# Public Review

## Vancouver Building By-law (VBBL)

### Proposed change to Parkade Security Requirements

**Code change number:** 24-0004

**Figure A-3.3.7.7.(3) & (4)**

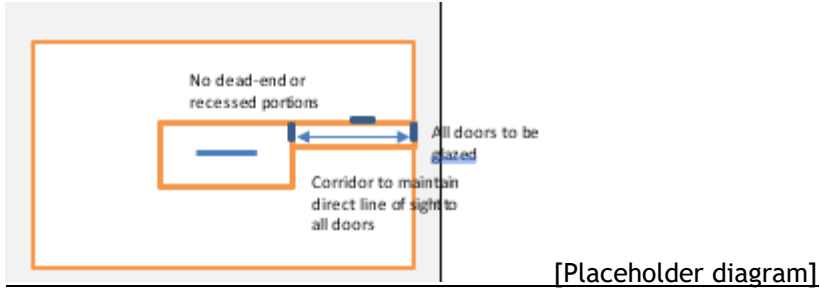
Clause (4)(b) is intended to provide a relaxation for mixed use buildings where reasonable security features have been implemented to ensure that occupant are not subject to an unacceptable risk of physical assault. Occupants using the exit are made aware of conditions in the exit due to increased visibility through glazed doors and clear sightlines, and can remain in a place of safety until they exit. Ancillary doors providing access to the exit serving the storage garage are to be provided with security measures to prevent general use of the exit by unauthorized persons, except for emergency egress.

a) which only serve the *storage garage*, do not provide a common path of travel for other *floor areas*, and exit directly outside the *building*, or

b) serve the *storage garage* and *floor areas* at the *exit* level where

i) the *exit* from the stair extends in a straight line to the exterior door without adjoining dead-ends corridors,

ii) interior and exterior doors in the *exit* from the *storage garage* to the exterior are designed to maximize visibility of the egress route, adjoining spaces within the *exit* enclosure, and spaces provided with door opening into the *exit* enclosure,

iii) doors providing access into the *storage garage* exit from *floor areas* other than the *storage garage* are provided with electromagnetic locking hardware in accordance with Sentence 3.4.6.16.(5) to secure access into the *exit* except during emergencies, and

iv) the *exit* corridor is provided with an average illumination level of at least 220 lx.
